RESPONSE TO SUBMISSIONS REPORT

The New Primary School in Mulgoa Rise - SSD-11070211

17 November 2021

DIAGRAM 2 - Overall Ground Floor Covered Structure Diagram – Proposed Development (NTS)

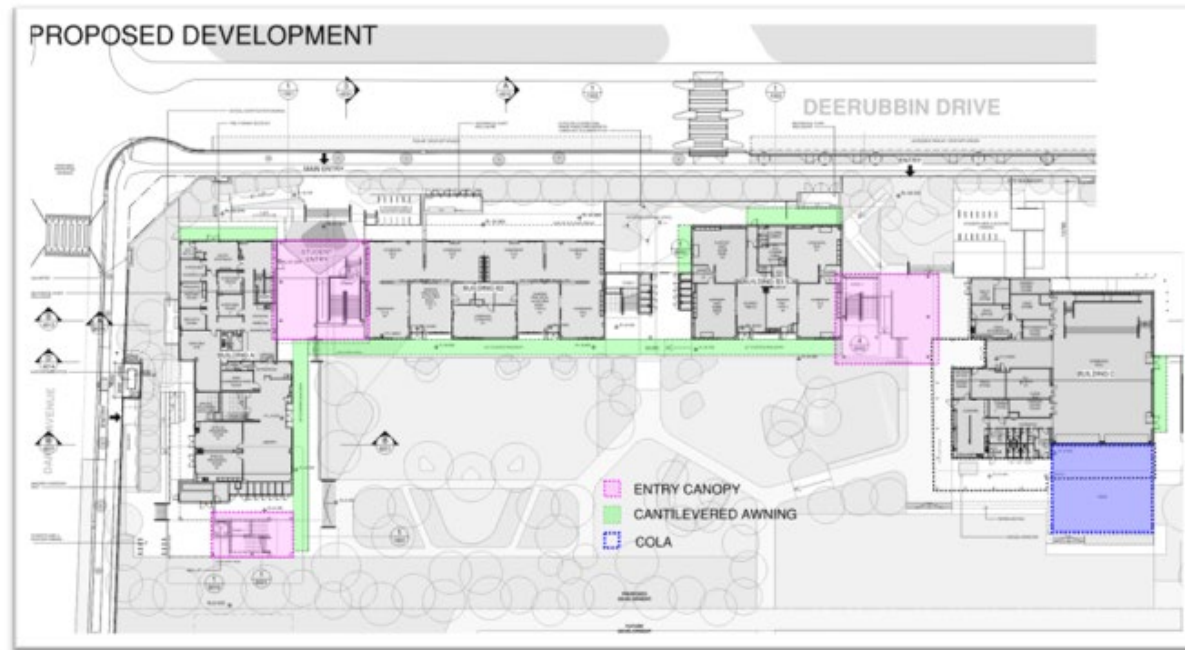
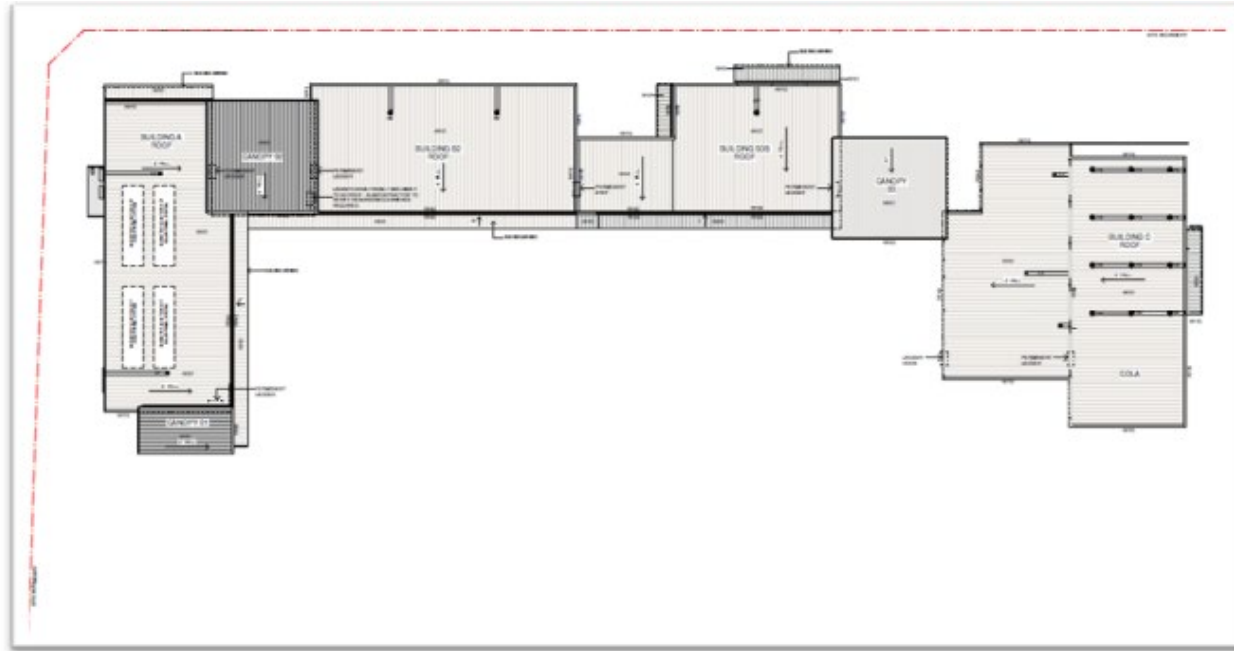
Proposed Action / Change	Reason for Action / Change
Architectural Design Changes	
<p>Canopies – size, location & form</p> <p>The area highlighted in Diagram 1 and Diagram 2 in the adjacent column illustrates the extent of additions and reductions of roof area.</p> <p>Skylights have been removed.</p> <p>The lower canopy to the west of Block C Hall has been relocated to the southern side of Block C and is now identified as the COLA.</p> <p>Further discussion on the COLA is outlined below.</p> <p>The proposed revised roof plan is illustrated on page 10.</p>	<p>This design rationalisation provides structural design efficiency for a more economical solution while still maintaining the canopies as an identifying design feature at the pedestrian entries along Deerubbin Dr and Darug Ave. Skylights have been removed due to complexity of maintenance.</p> <p>Awning placements have been rationalised to prevent overlapping with high-level canopies.</p>

Updated layout and external awnings of Block B3S

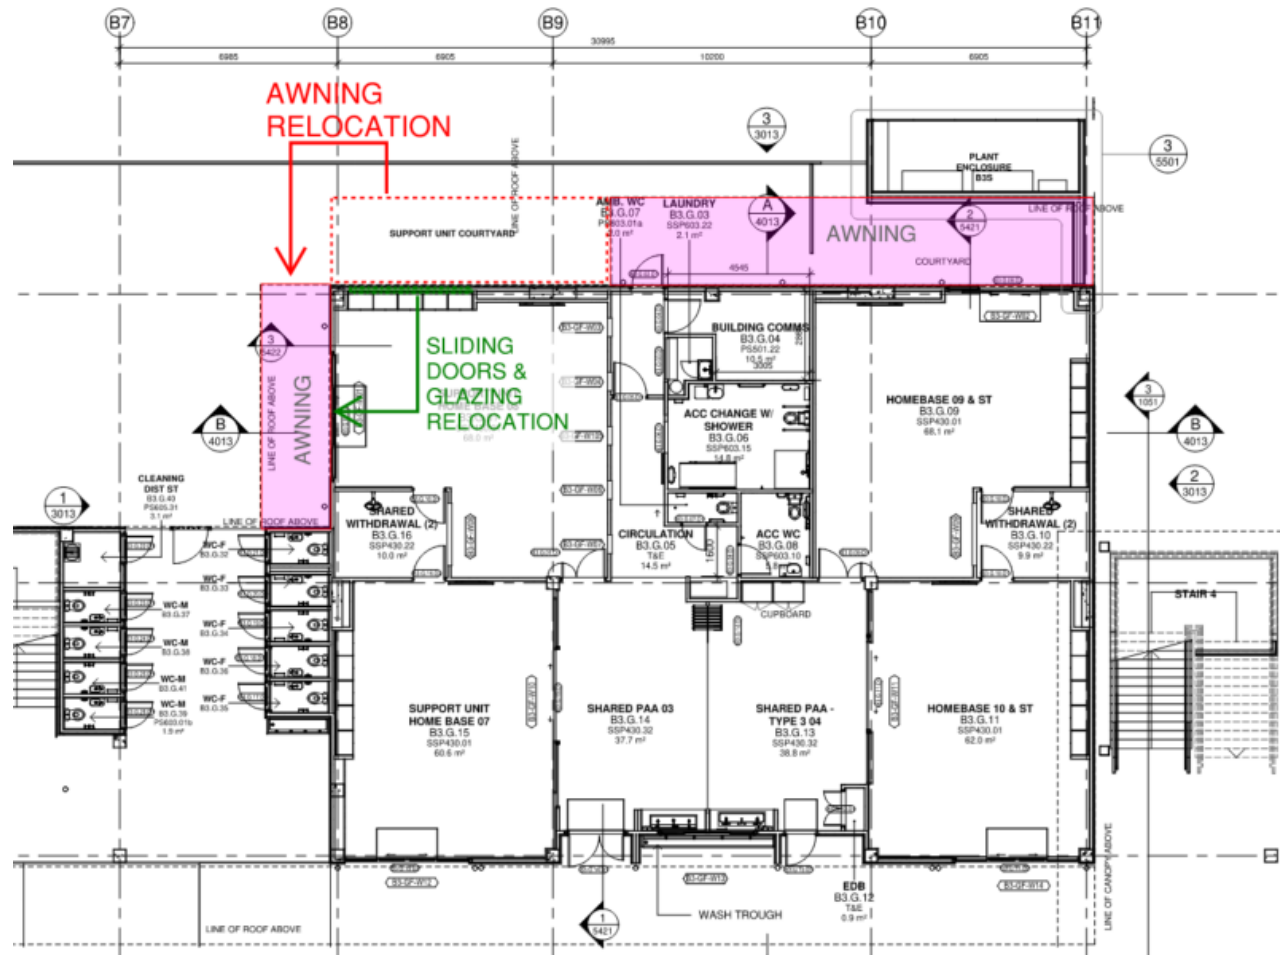
- Minor adjustment to the North & West Elevation of Block B3S.
- Change to glazed sliding door location.

The glazed sliding door connecting the support unit to the outdoor learning area has been relocated from the northern façade to the western façade including associated awnings above to align with the movement of the awning to the western side of Block 3.
The location of Stair 3 and student amenities between Block B2 and Block B3S have been swapped to achieve better circulation between Level 1 and the play area. These changes have subsequently required minor adjustment to the North and West Elevation of Block B3S.

Security and fencing

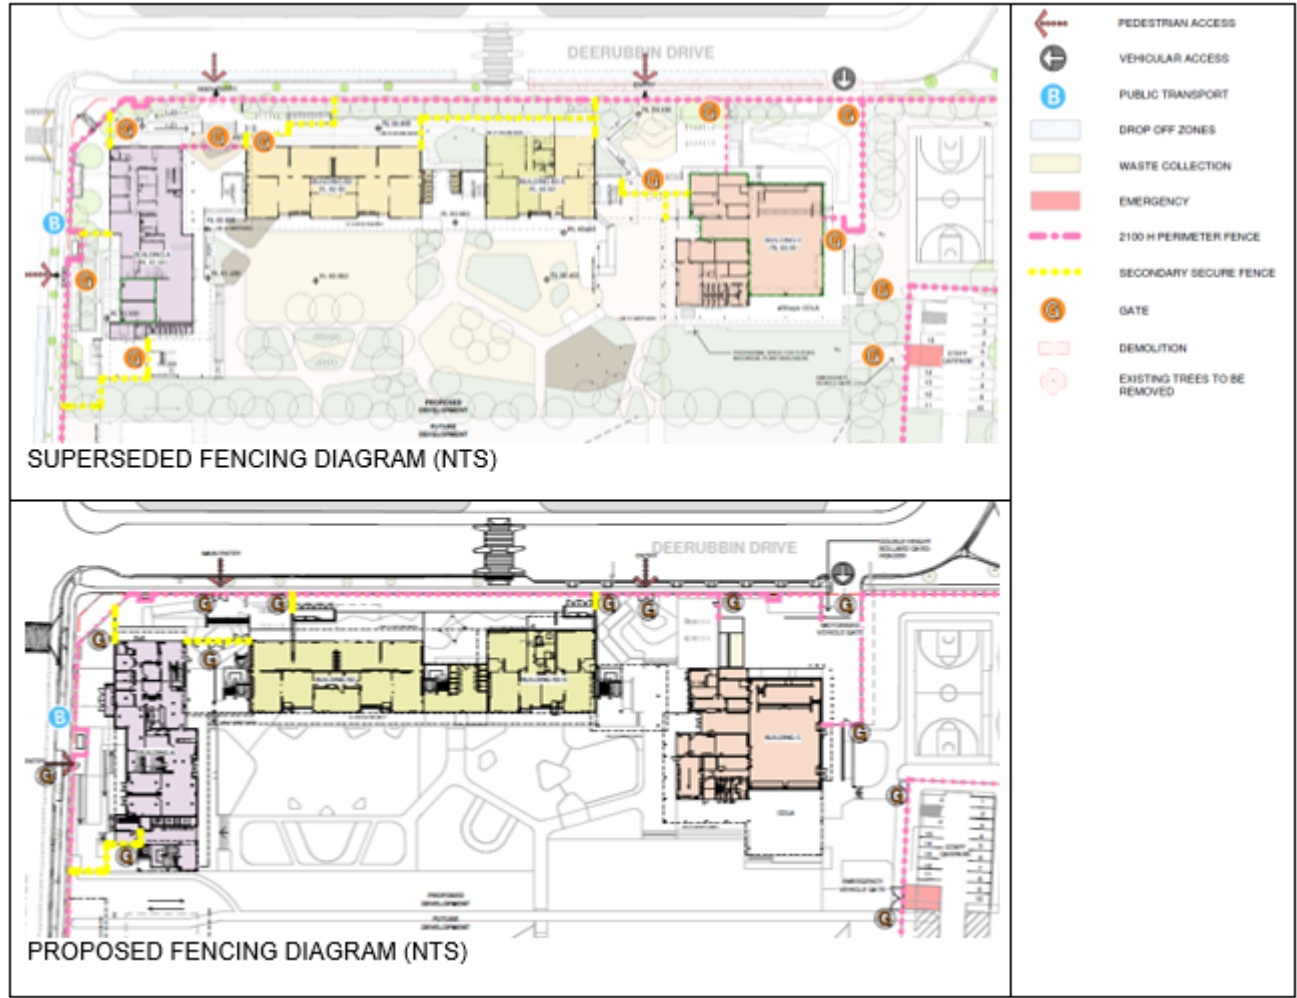
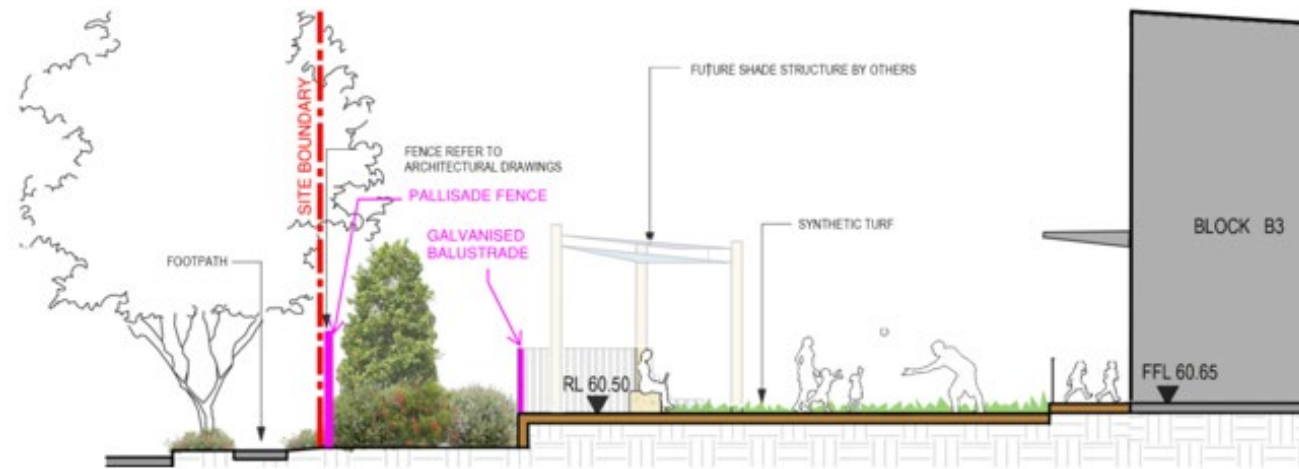
Elimination of secondary fencing. The changes are illustrated in the diagrams in the adjacent column.

Further design development of the outdoor learning area between home base blocks B2 and B3S resulted with the elimination of much of the secondary security fence parallel to the boundary. Level changes in these areas will be managed via balustrades.

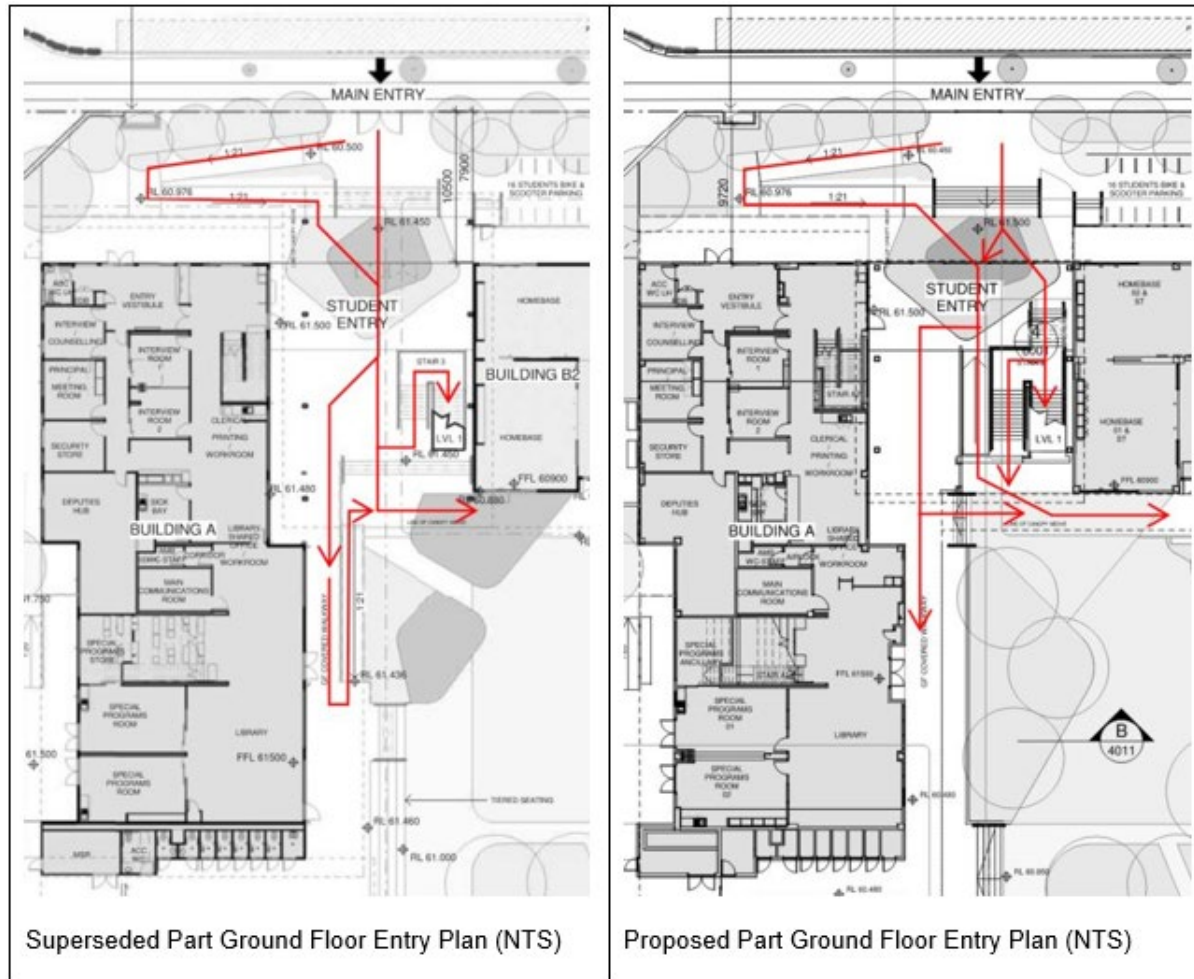
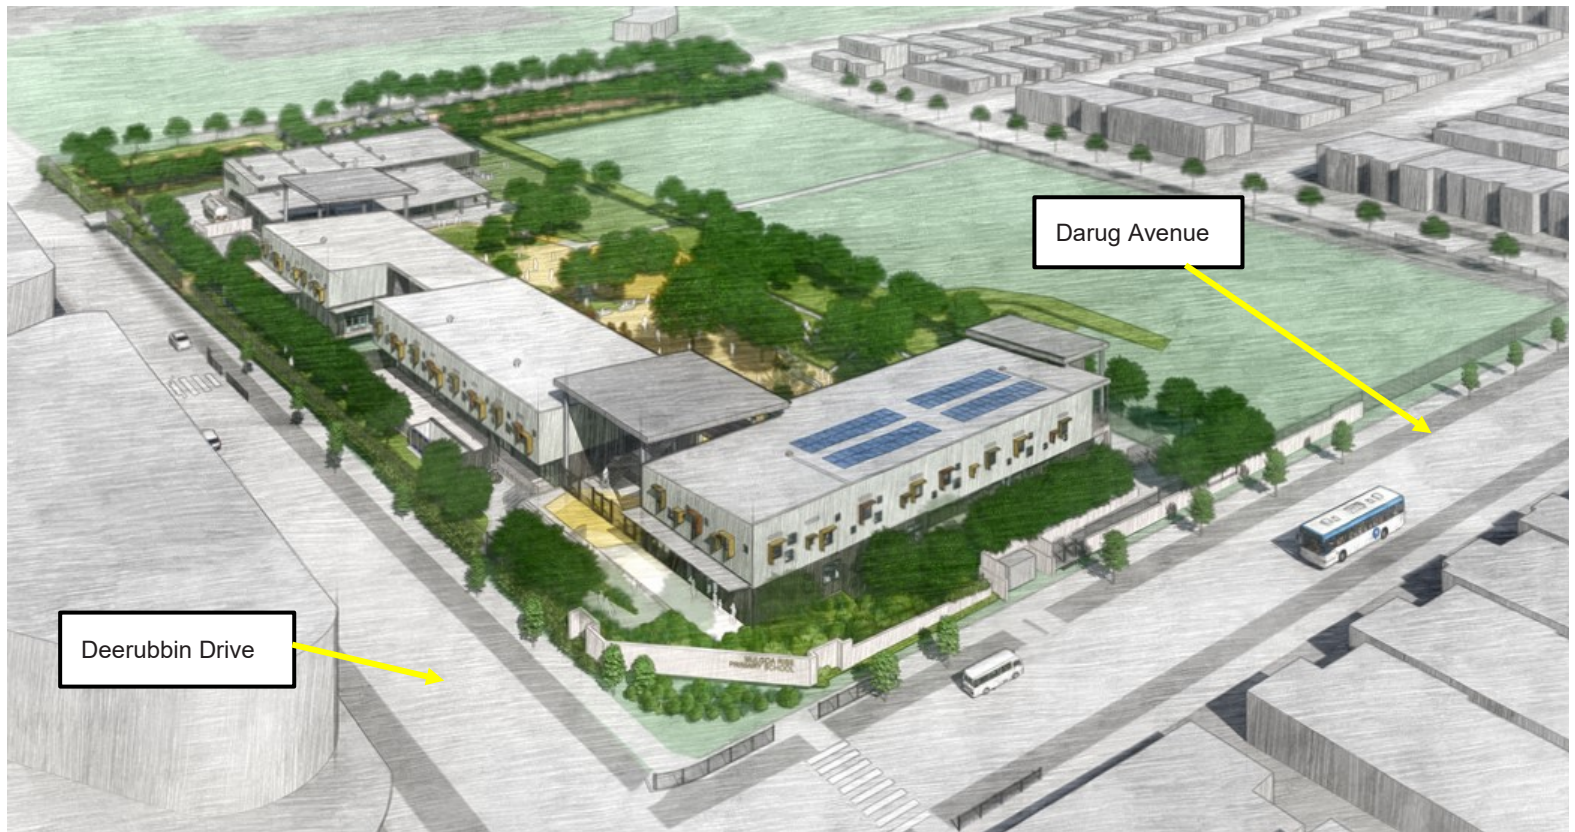
Layout of the main entry has been redesigned. The changes are illustrated in the diagrams in the adjacent column. An aerial perspective of the school, incorporating the proposed changes, is provided on page 16. Street level images of the school, incorporating the proposed changes, as viewed from Deerubbin Drive, are provided on pages 17 and 18. An Updated Visual Impact Assessment is contained in **Appendix F.**

Redesigned has occurred to better comply with egress paths and minimise travel distances; improve the circulation and student flow at peak times; ensure a covered path is always maintained.

Relocation of services plant spaces

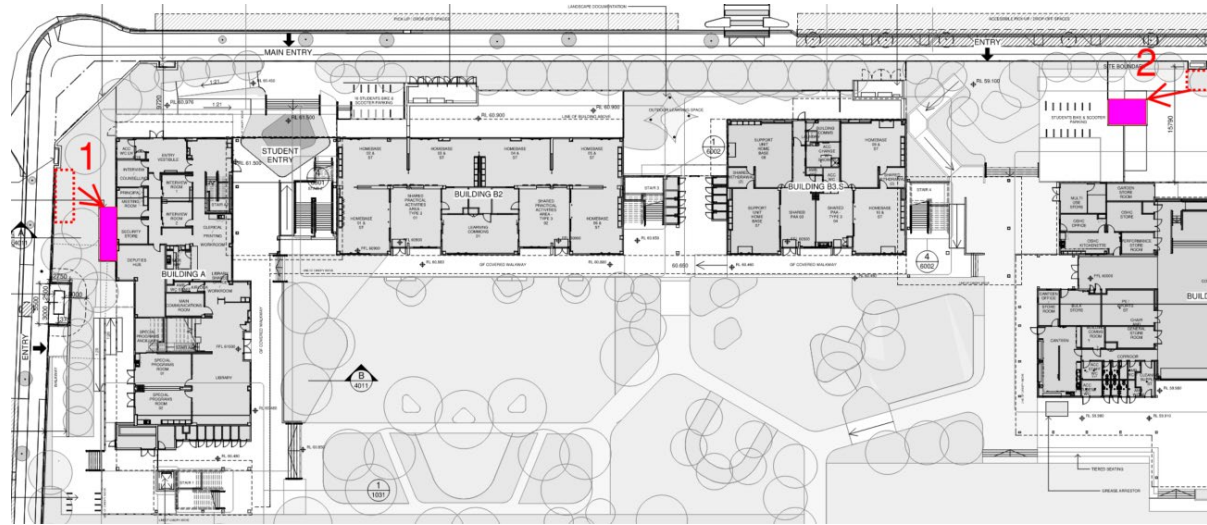
- Change 1 - The mechanical plant of Block A has been relocated from the site boundary on Darug Ave to sit adjacent to the building, on the western façade.
- Change 2 - The cold-water pump and fire hydrant pump have been set back from the boundary of Deerubbin Drive, closer to Block C.

Relocation of the mechanical plant was to facilitate better services reticulation. All windows located immediately adjacent to and directly above the plant will be upgraded to using thicker laminated glass for better acoustic attenuation.

Landscape Plan - Previous SSDA (NTS)

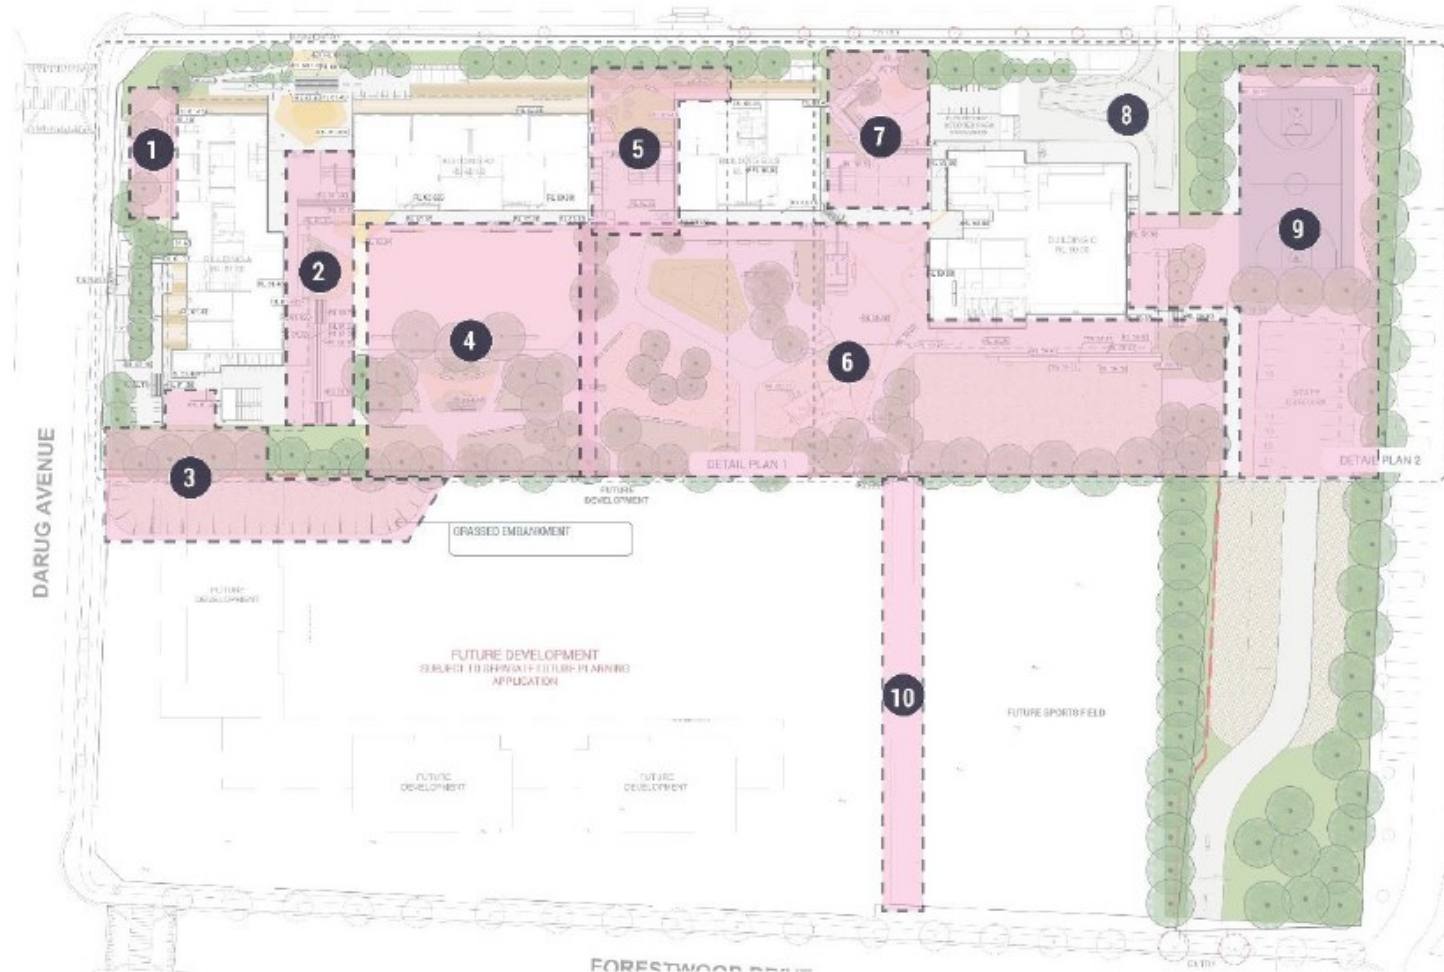
The areas highlighted on the diagrams in the adjacent column illustrate the extent of change to the Landscape area. Further details are outlined in **Appendix D**.

1. Mechanical location revised; lawn area replaced with mass planting
2. Access to Block A from main entry, Block B2, B3S and Block C revised, details as follows
 - A. 1:14 ramp in lieu of 1:21 walkway (previously in front of Block A) to allow for a shorter route and more direct access
 - B. Increase in landscape area in lieu of 1:21 walkway
 - C. Bleacher seating omitted; stair width increased to accommodate for circulation.
3. Temporary landscaped embankment reduced in size, additional landscaped area in lieu of concrete paving to the west side of stair 1.
4. Assembly area developed
 - A. Pocket landscape area with trees introduced.
 - B. Interpretive Line marking incorporated
 - C. Outdoor learning area updated for Yarning Circle opportunities

- D. Educational Trail / Explorative Play in lieu of concrete paths
- 5. Outdoor play area to support unit
 - A. Timber decking omitted
 - B. Access ramp revised to suit the new location of toilet block
- 6. Consolidated sensory play
 - A. Synthetic turf mound location revised
 - B. Yarning Circle opportunities included at mulched play area
 - C. Turf open play area increased
 - D. Revised Bleacher Seating to revised COLA extent
 - E. Incidental Nature play
- 7. New accessible ramp introduced to allow for a more direct access
- 8. Services area revised
- 9. Sports & Carpark
 - A. Hard paving reduced around basketball court
 - B. Coloured concrete finish for basketball court in lieu of plexipave
 - C. Emergency vehicle access revised
- 10. Access to Forestwood Drive revised.
